### First floor plan view

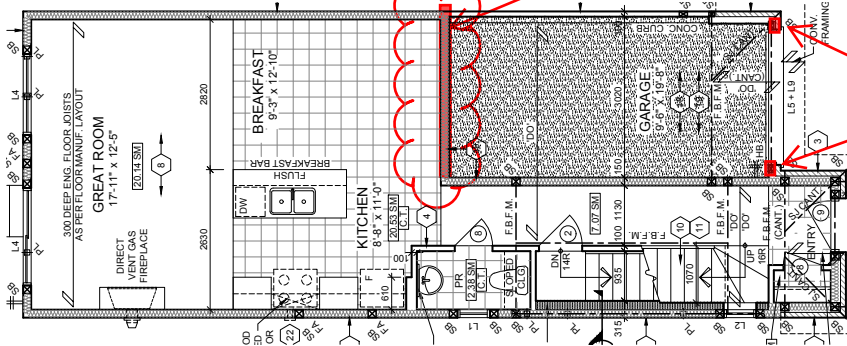
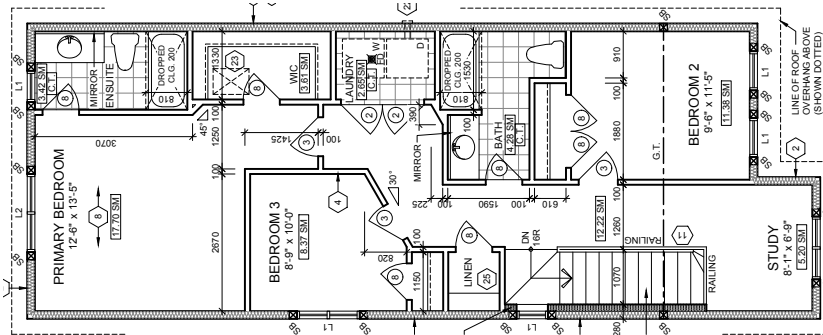
Can this wall to be considered as shear wall?

What if the wall adjacent to garage door doesn't satisfy the height/width ratio for shear wall criteria?
